# Smithfield - LH

**Lot 134 - Duncan's Creek**

## 'FRENCH COUNTRY' ARCHITECTURAL DRAWINGS

Redlines completed 21-Aug-24 - DP

**SECOND FLOOR PLAN 'FRENCH COUNTRY'**  
SCALE: 1/8"=1'-0" ON 11x17, 1/4"=1'-0" ON 22x34

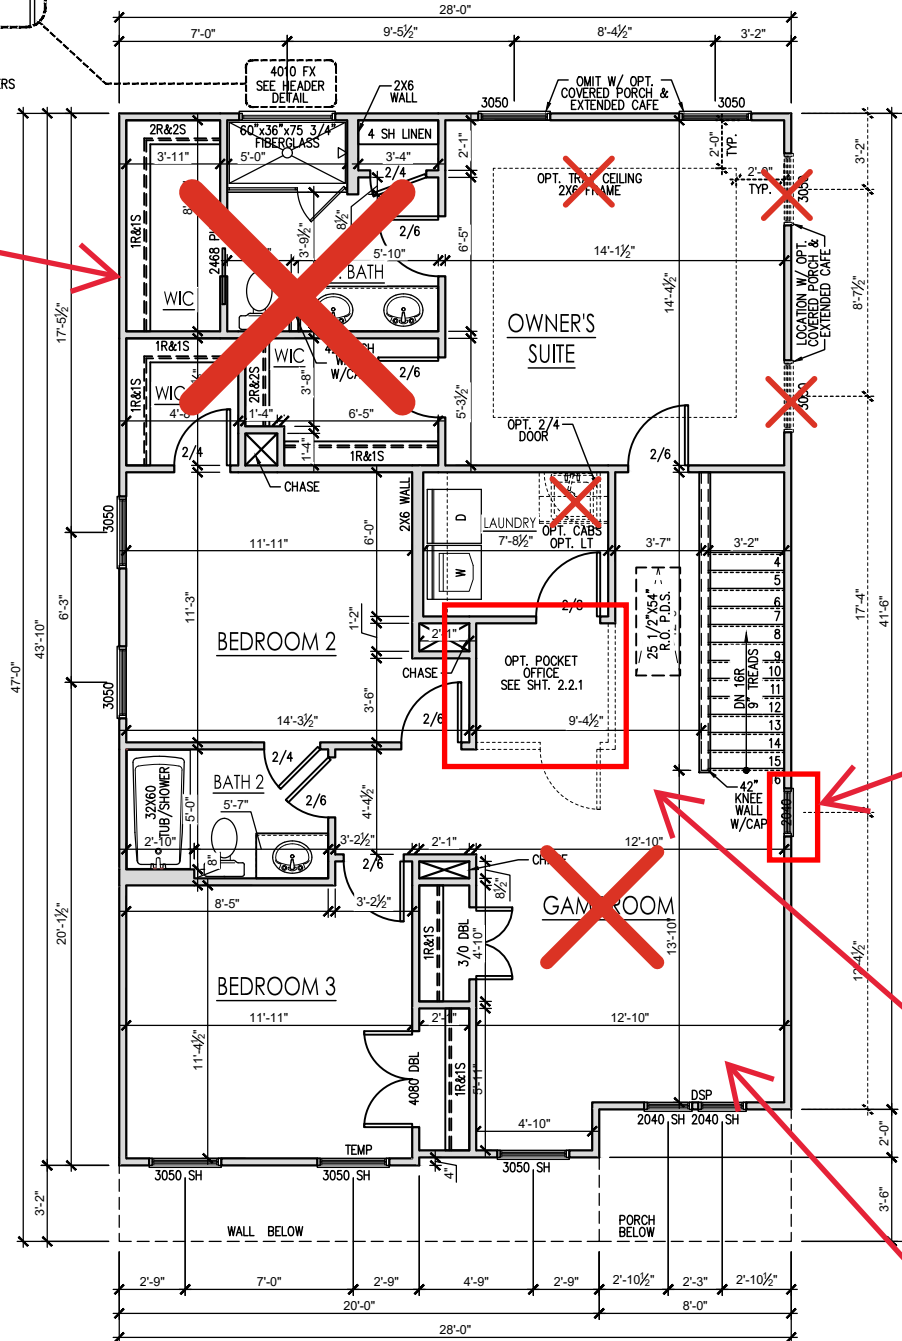
Add 20x40 window at top of stairs.
